**ADDENDUM # 10**

**WEGO Transit and Fleet Operations Center Expansion**

**Request for Proposal No: RFP-22-2024-AD**  
**Issue Date of Addendum: January 16, 2025**  
**Proposal Submission Deadline: January 23, 2025 at 2:00 p.m. ET**

**ADDENDUM No.2**

**5 TYP. COLUMN EXTENSION THROUGH ROOF**  
scale: 1 : 5

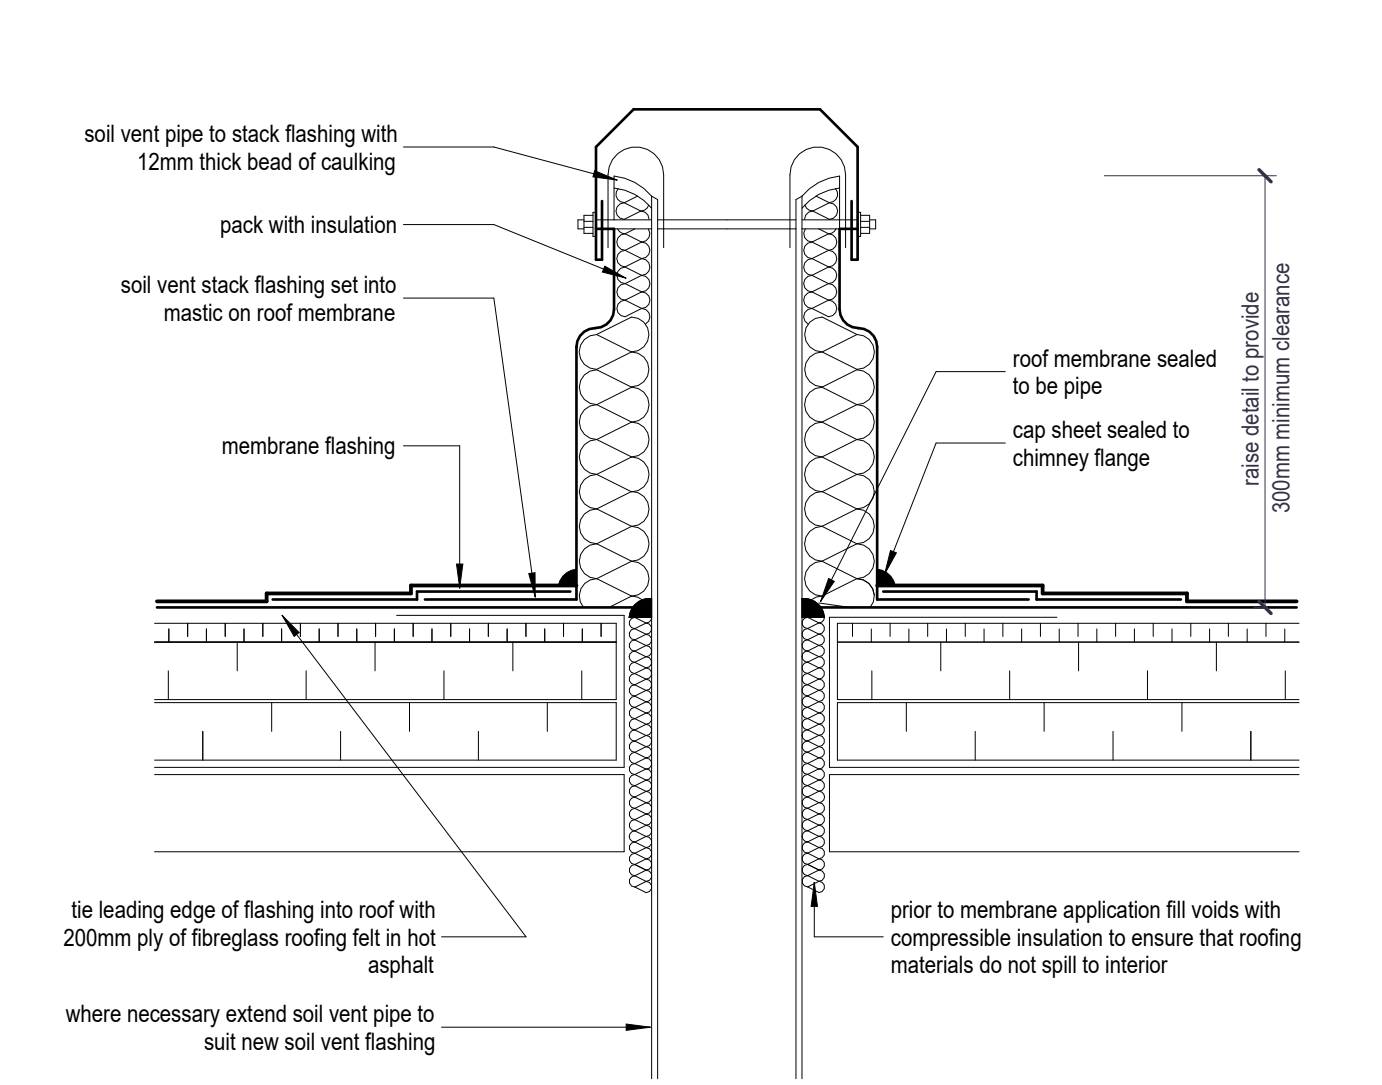
drawings for this scope of work? Additionally, one of the roofers has suggested that mechanically fastened iso takes longer than non-mechanically fastened. Furthermore, the current roofing details and drawings are somewhat vague and generalized. It would be greatly appreciated if you could revise to include more specific callouts and details, particularly for the proper walls/parapets, and divisions of the roof.

**ANSWER:** Refer to A9-200 for roof details added at existing.

**2ND FLOOR FRAMING PLAN**

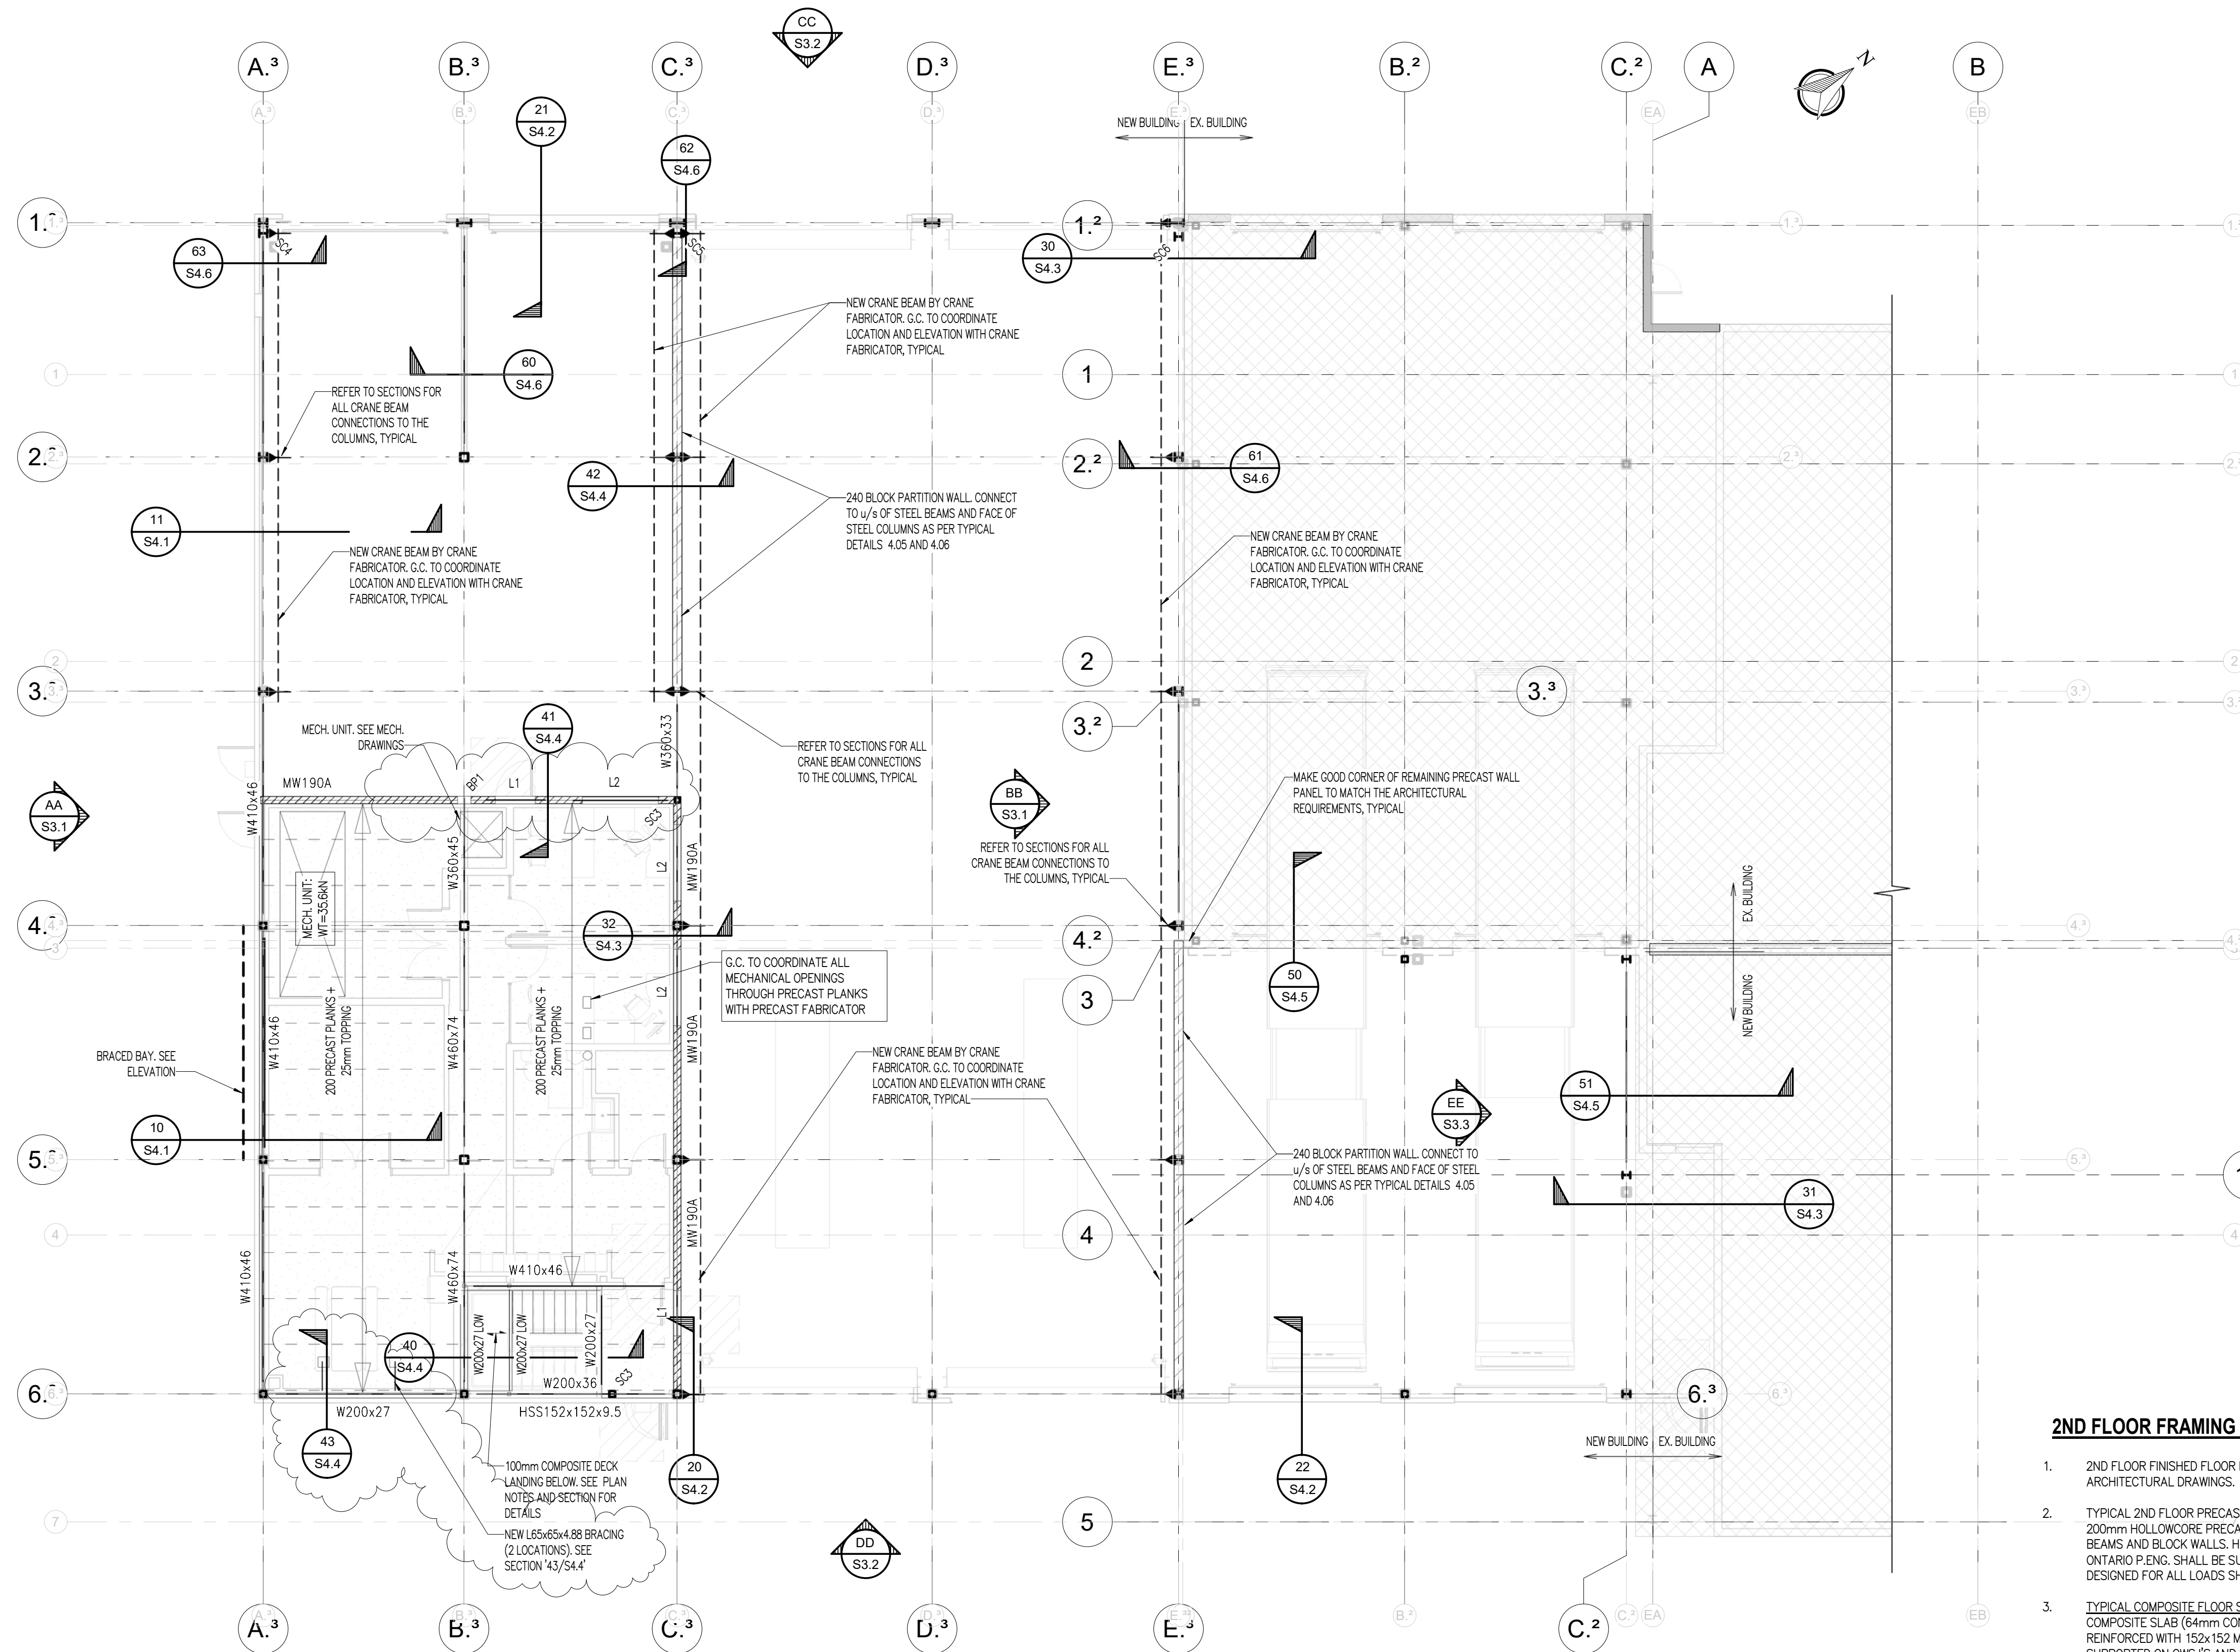
**1.1 Refer to attached Structural Drawing S1.1 – 2<sup>nd</sup> Floor Framing Plan**

- b) Refer to the clouded area at the north end of the interior mezzanine for the revised location of lintel 'L1' and the addition of a new lintel 'L2'.
- c) Refer to the Grid '6<sup>3</sup>' and 'A<sup>3</sup>' for the new section '43' for the bracing of the bottom flange of the W200 beam. Refer to attached drawing S4.4 for the new section '43'.
